PCN: V21-001-476103-OA

Product Change Notice

- 1) Shipping tray design.

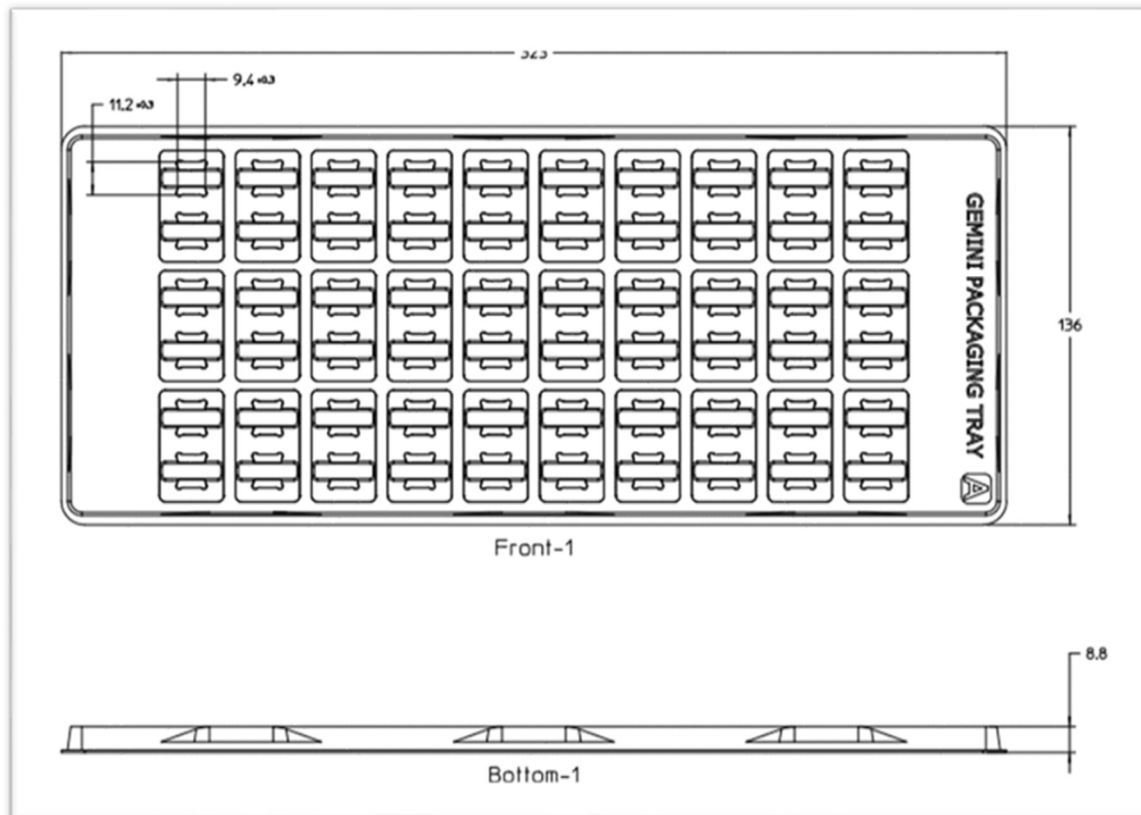
- Current Tray Design, (Tray dimension: W = 136mm, L = 323mm, H = 8.8mm)

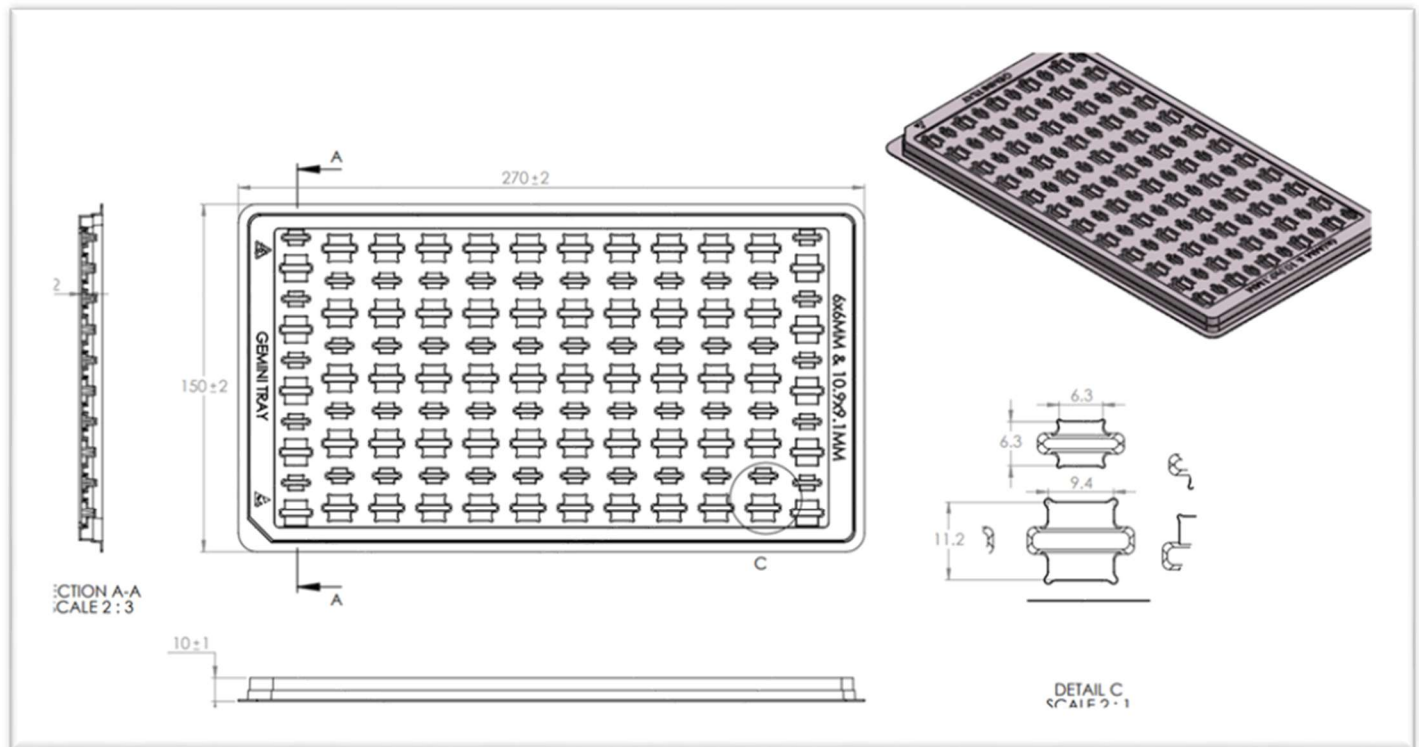
- **New Tray Design, (Tray dimension: W = 150mm, L = 270mm, H = 10mm)**
